Docket No. '50-271

AMENDMENT TO FACILITY OPERATING LICENSE

Amendment No. 12
License No. DPR-28

CHANGE NO. 23 TO THE TECHNICAL SPECIFICATIONS

Figure 1.1.1 Fuel Cladding Integrity Safety Limit

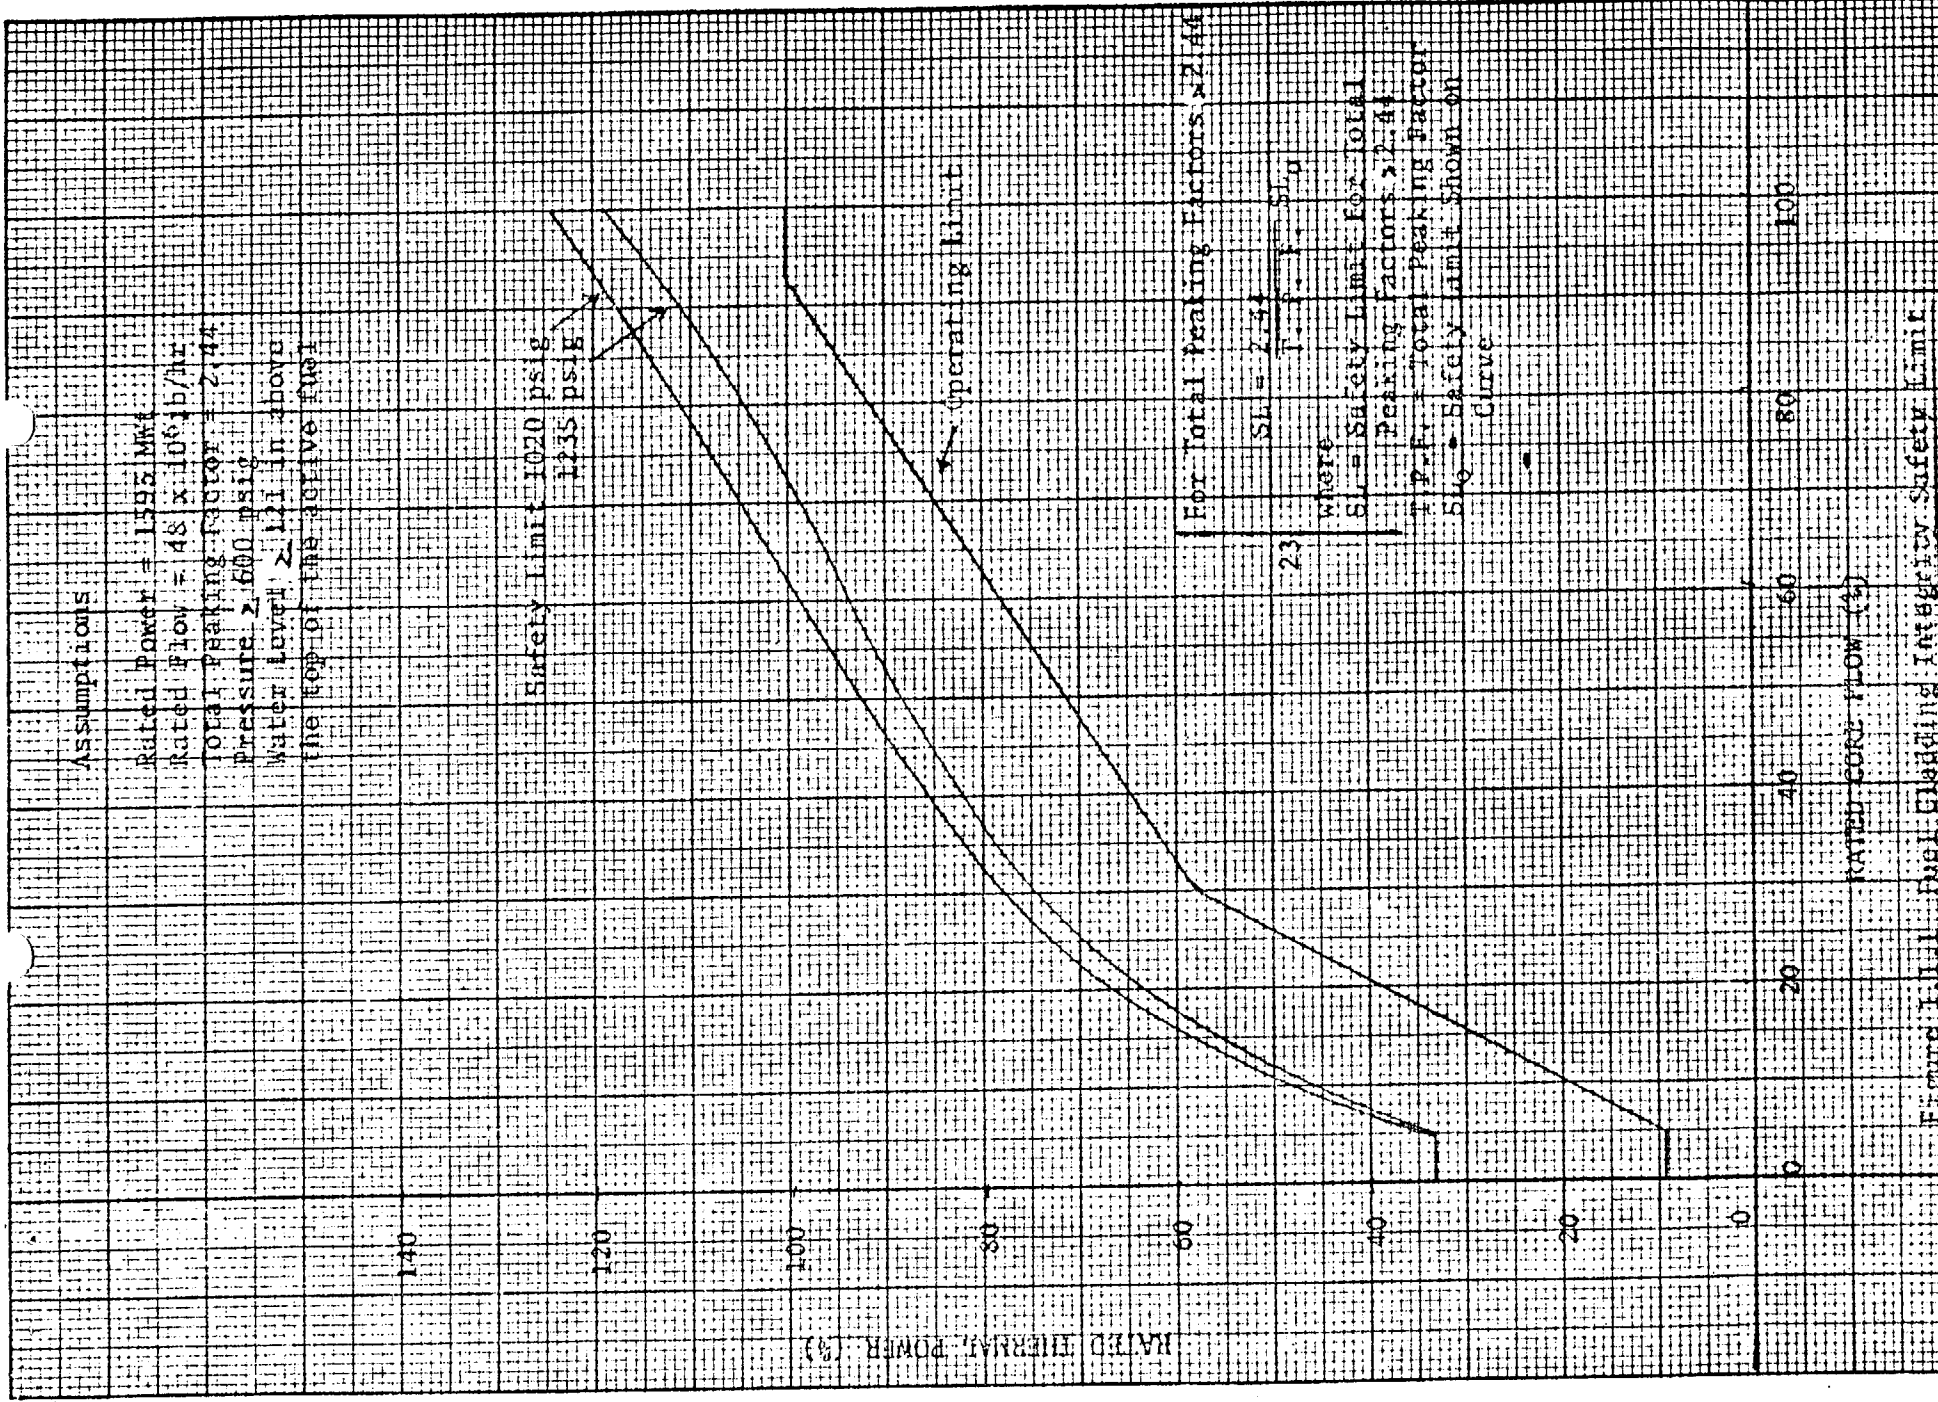
- 23 | The power shape assumed in the calculation of these curves was based on design limits and results in a total peaking factor of 2.44 (1). For any peaking of smaller magnitude, the curves are conservative. The actual power distribution in the core is established by specified control rod sequences and is monitored continuously by the Local Power Range Monitor System (LPRM). To maintain applicability of the safety limit curve, the safety limit will be lowered according to the correction factor given on Figure 1.1.1 in the rare event of power operation with a total peaking factor in excess of 2.44.

23 | The thermal hydraulic safety limit of Specification 1.1 was based on a total peaking factor of 2.44. A correction factor has been included on Figure 1.1.1 to adjust the safety limit in the event the peaking factor exceeds 2.44. Likewise, the scram setting should also be adjusted to assure MCHFR does not become less than 1.0 in this degraded situation. If a peaking factor greater than 2.44 exists, the APRM scram setting is adjusted downward by the equation given in the specification. The scram setting as given by the equation will prevent MCHFR from becoming less than 1.0 for the worst expected transients. If the APRM scram setting should require a change due to an abnormal peaking condition, it will be done as indicated in Specification 2.1.A.1.

Curves are presented for two different pressures in Figure 1.1.1. The upper curve is based on a nominal operating pressure of 1020 psig. The lower curve is based on a pressure of 1235 psig.

Figure 3.5.1. Maximum Allowable Planned Dose

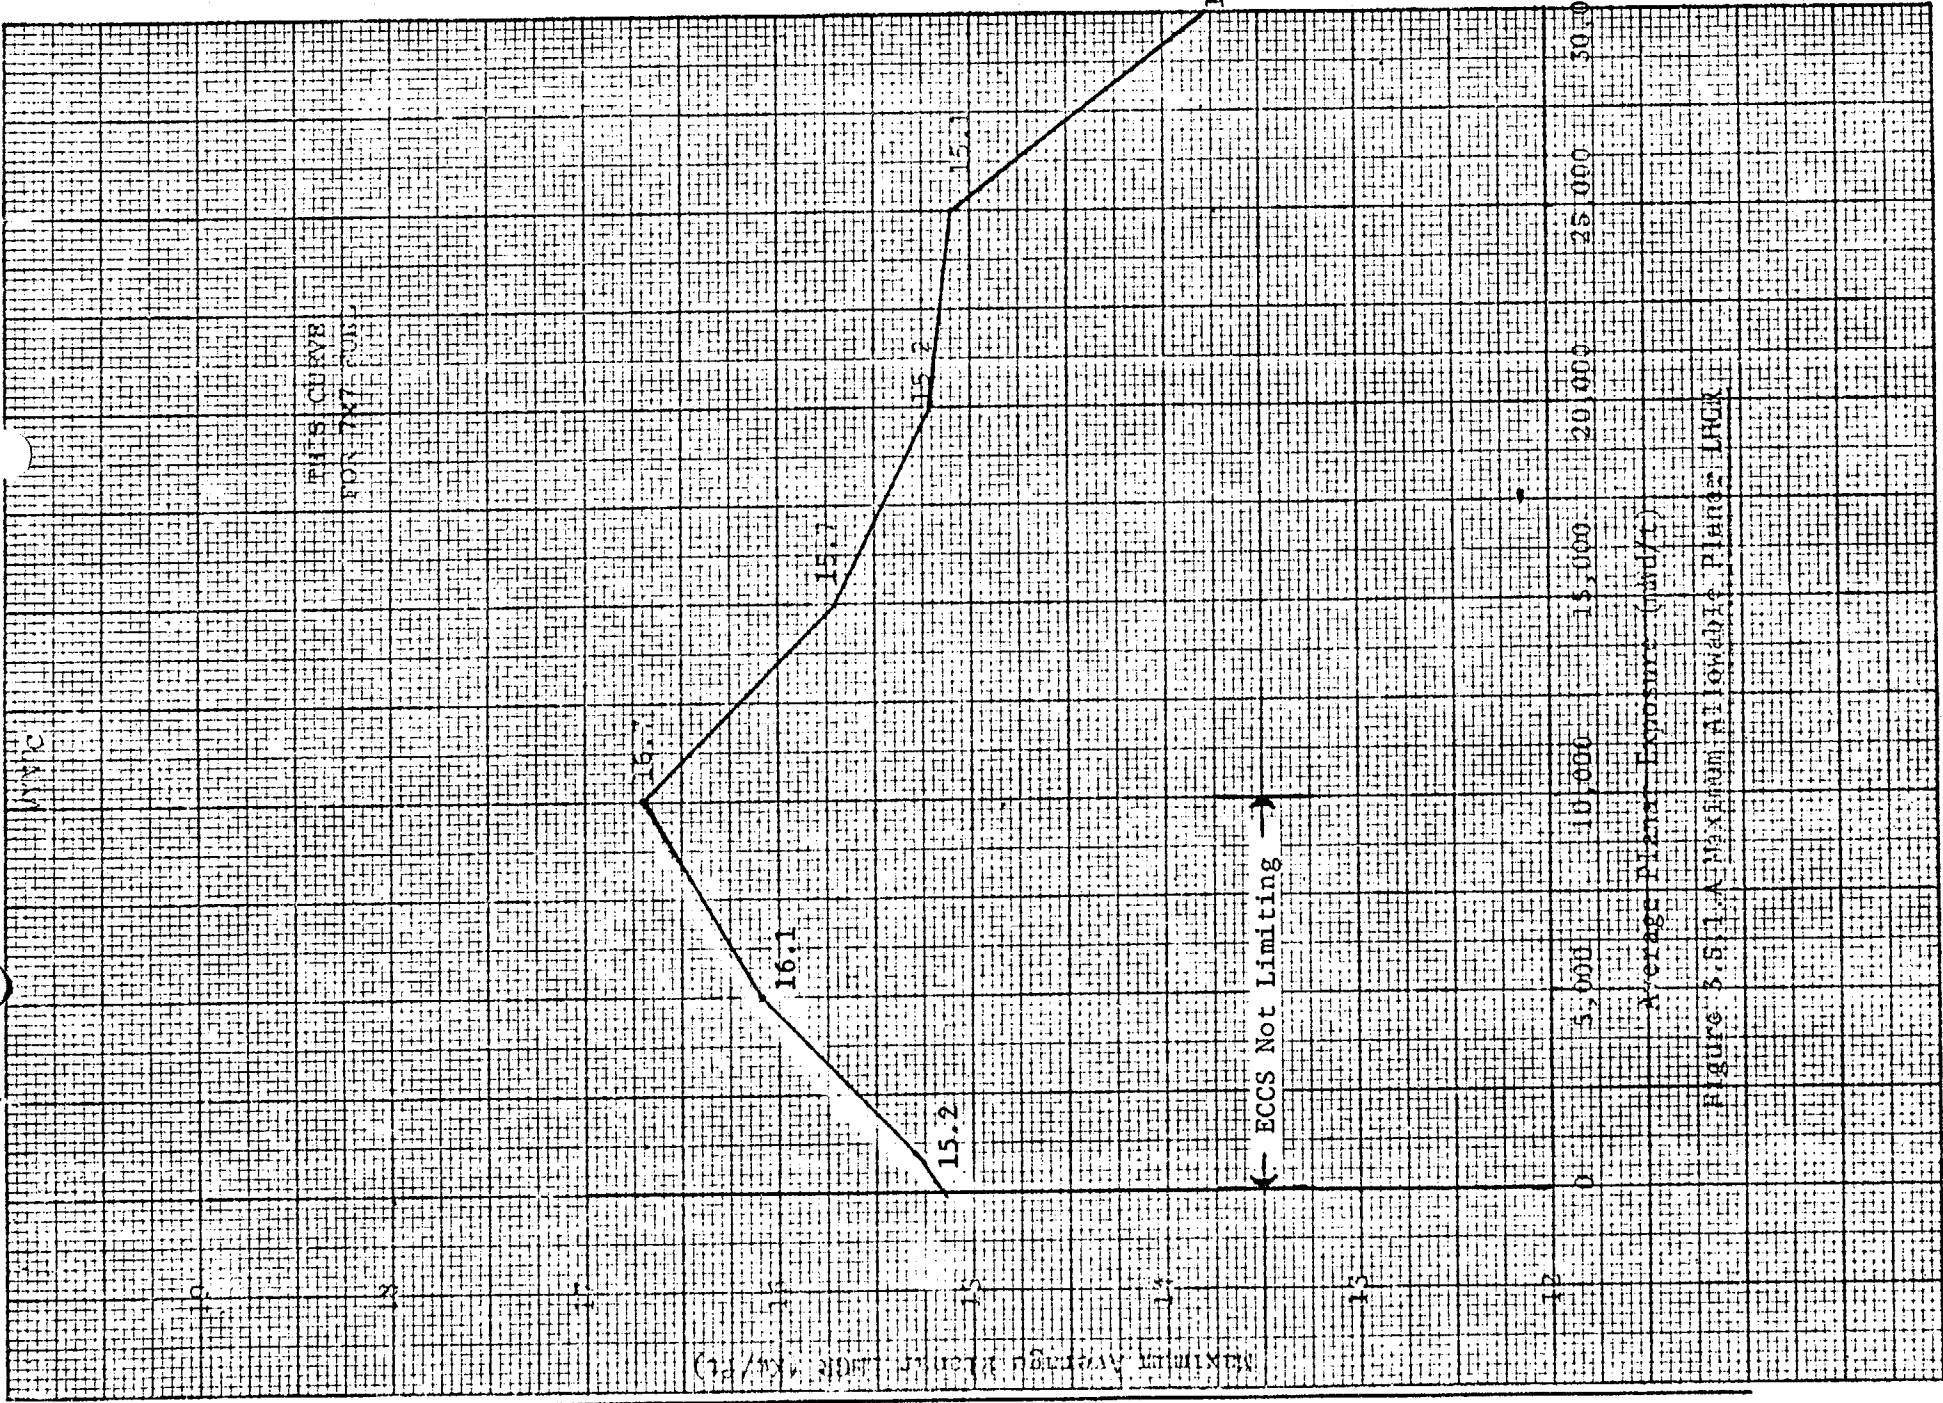
23 | During steady state power operation, the APLHGR for each type of fuel as a function of average planar exposure shall not exceed the limiting value shown in Figure 3.5.1. If at any time during steady state operation it is determined by normal surveillance that the limiting value for APLHGR is being exceeded action shall then be initiated to restore operation to within the prescribed limits. Surveillance and corresponding action shall continue until the prescribed limits are again being met.

6. The maximum average planar LHGR curve related to the IAC for the 8 x 8 fuel assemblies has been added in accordance with Paragraph 50.46 of 10 CFR Part 50 as an interim measure until we have reviewed and approved the method of analysis in accordance with Appendix K criteria. VYNPC has submitted the required ECCS analysis by letter dated October 31, 1974 which is being reviewed. The maximum average planar LHGR curve for the 7 x 7 fuel assemblies has been changed to take into account the modification of the ECCS approved by our letter dated November 1, 1974. Other changes relating to the surveillance of the average planar LHGR have been made for the same reason stated above for the local LHGR surveillance.

Figure 1 Reference Core Loading Pattern

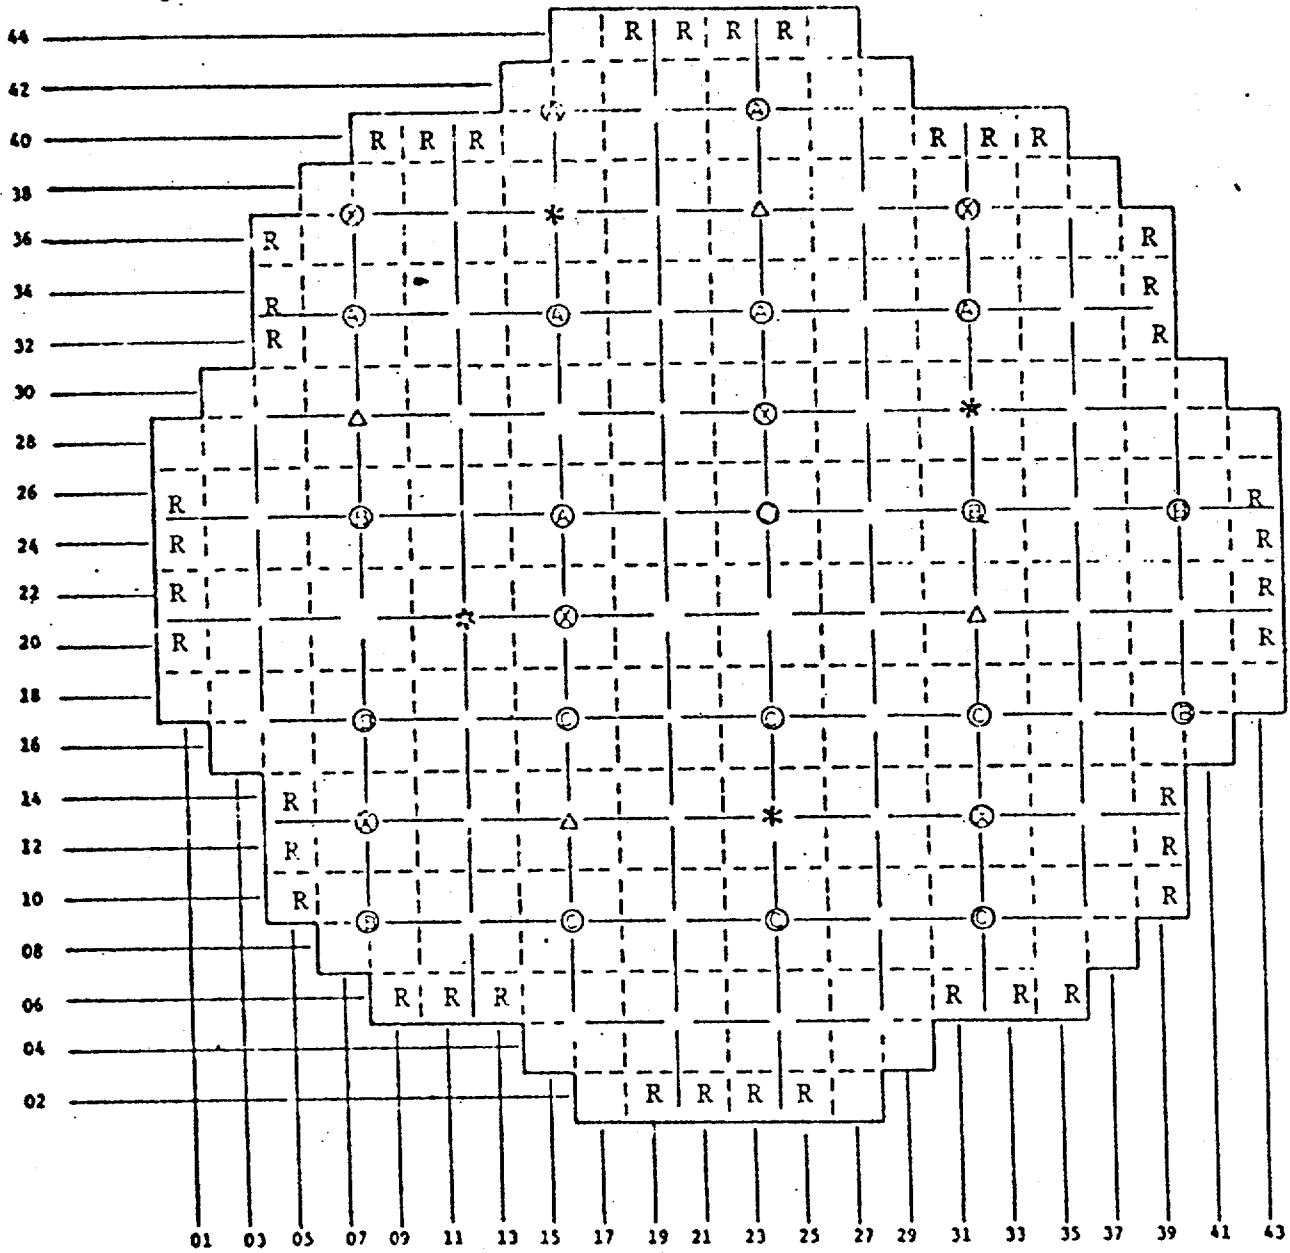
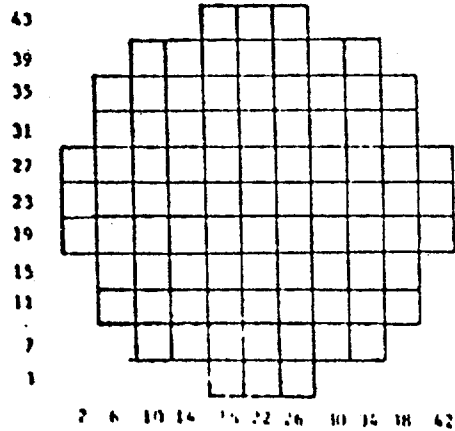
The 8 x 8 reload fuel has been designed to be compatible with and closely match the mechanical, nuclear, and thermal-hydraulic characteristics of the VYNPS initial core and the previous reload 7 x 7 fuel. The reference core is based on a pattern of reloading the 8 x 8 fuel as shown by Figure 1. No significant fuel loading asymmetries will exist. Only 40 Reload - 1 fuel assemblies (7 x 7 fuel) will remain in the core, as shown in Figure 1, with the 328 Reload - 2 fuel assemblies (8 x 8). The location of the remaining Reload - 1 fuel assemblies on the periphery of the core
